Correspondence Between
Staff and Applicant
Approval Letter

RE: 12-MD-2018

101 Mega Raintree LLC

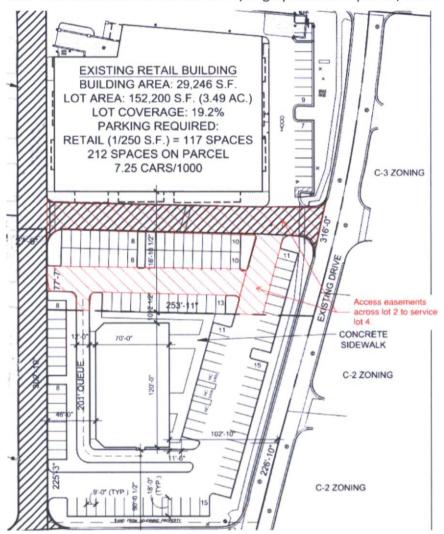
Please revise the project plans to provide a minimum 24-foot-wide drive aisle width on all proposed lots. As currently shown, proposed ingress and egress easement within Lot 2 and along western property boundary of Lot 4 do not meet requirement. (DSPM, Sec. 2-1.303) 5. Please revise the project plans to provide a cross access and emergency service access easement east-west across Lot 2 to service Lot 4 per graphic below. (DSPM, Sec. 5-3.201)

Please revise the project plans to provide a cross access and emergency services access easement to connect and overlap existing easements along southern property line of Lot 3 per graphic below. (DSPM, Sec. 5-3.201)
